Franklin County Health Department
Environmental Health Section
107 Industrial Drive-Suite C
Louisburg, North Carolina 27549

Permit Number: 2713 Type: E PIN : 1870-70-2146 Date: 5/30/2006

Subdivision: BARHAM PLACE Lot Number: 28 Size: 1.150

Den-Mark Construction
Barham Place Lot 28
Septic System Modification
Due to Proposed Pool Site
and an increase in Septic Area from a 4-Bedroom
to a 5-Bedroom Septic System.

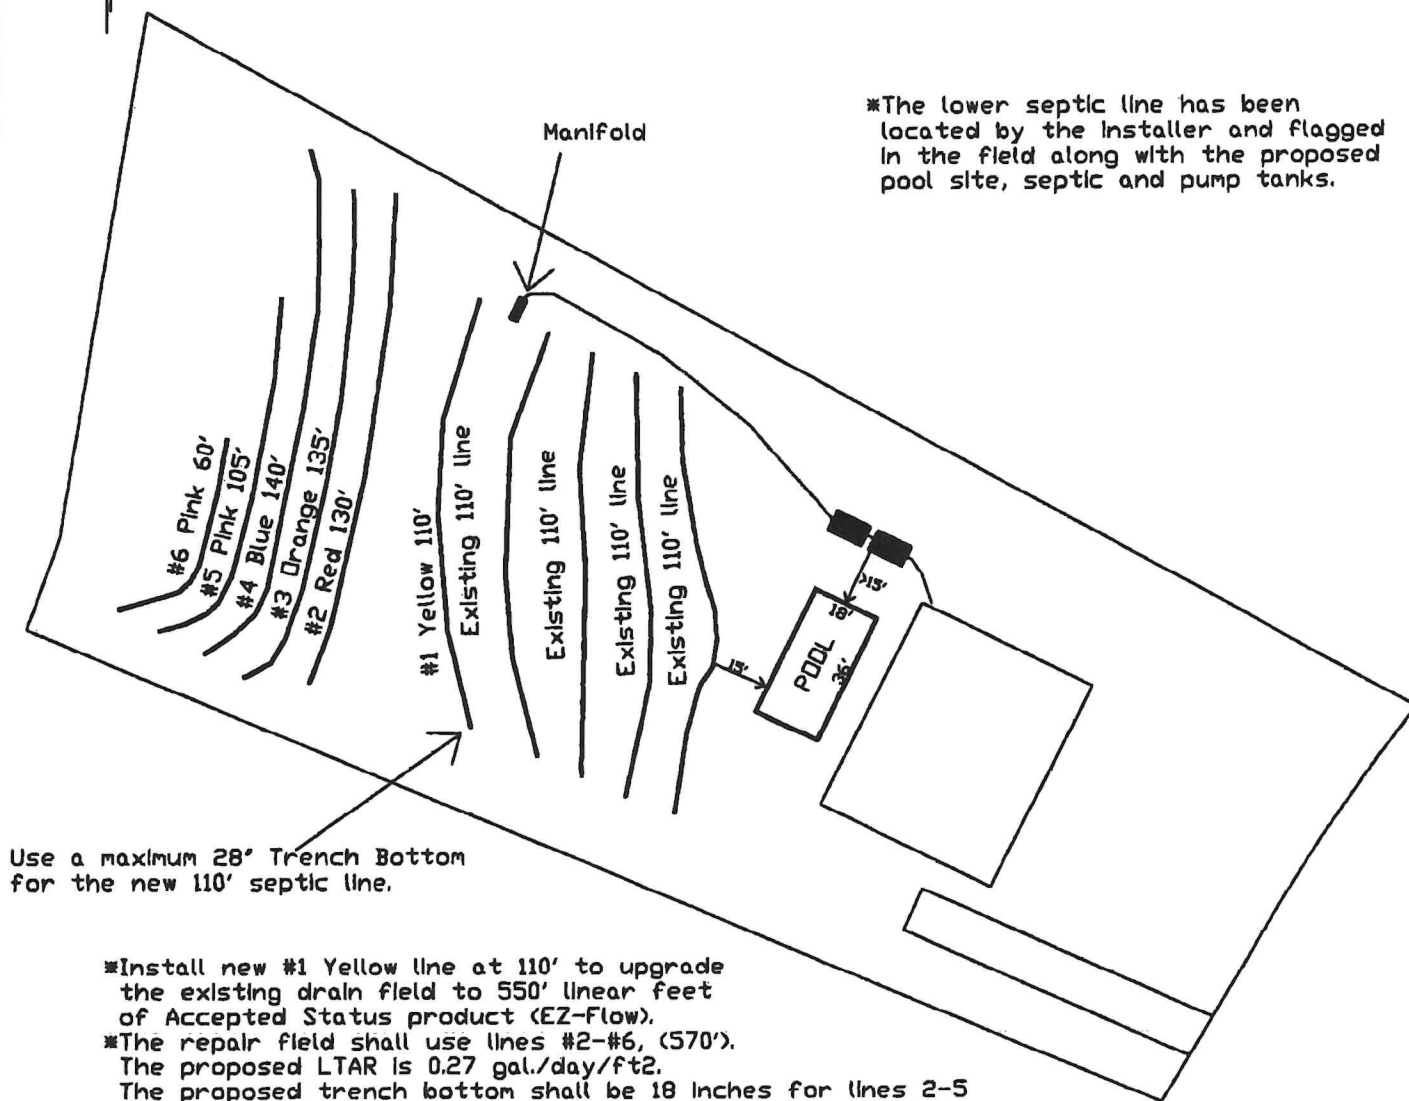
*The lower septic line has been located by the installer and flagged in the field along with the proposed pool site, septic and pump tanks.

Use a maximum 28" Trench Bottom for the new 110' septic line.

*Install new #1 Yellow line at 110' to upgrade the existing drain field to 550' linear feet of Accepted Status product (EZ-Flow).

*The repair field shall use lines #2-#6, (570'). The proposed LTAR is 0.27 gal./day/ft².

The proposed trench bottom shall be 18 inches for lines 2-5 and 15 inches for line #6 which will require approved fill material over the drain line.

15 feet from waters edge of pool to any drain line and tanks.

The concrete skirt around pool must not be constructed over top any drain lines or tanks.

Central Carolina
Soil Consulting
919-784-9449
Project # 154

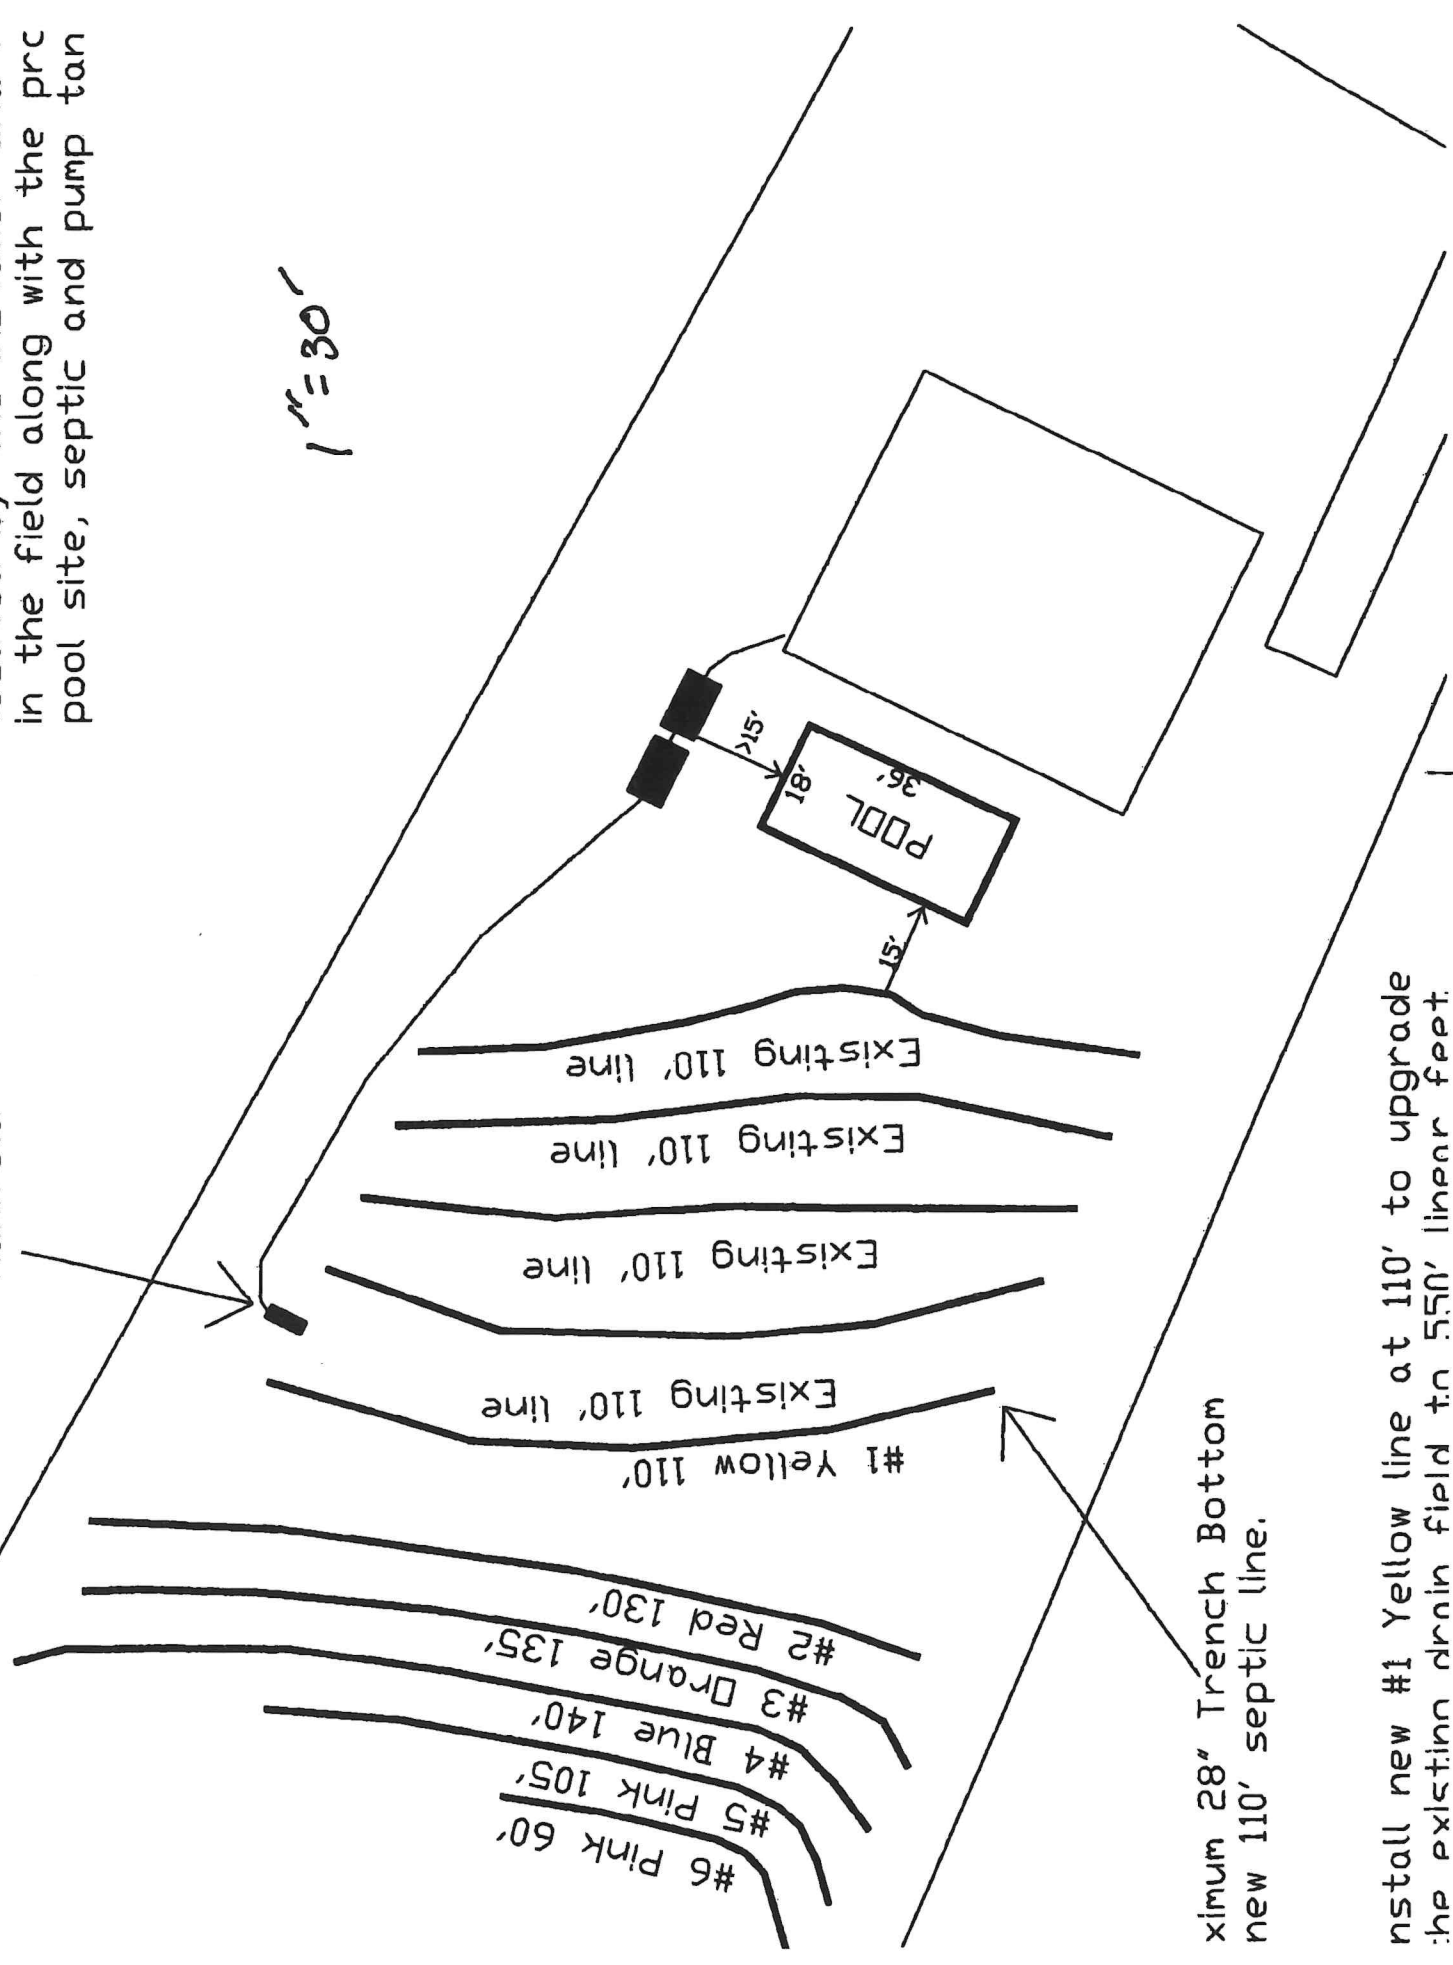
*The lower septic line has been located by the installer and located in the field along with the pool site, septic and pump tank

Maximum 28" Trench Bottom
new 110' septic line.

Install new #1 Yellow line at 110' to upgrade
the existing drain field to 550' linear feet.
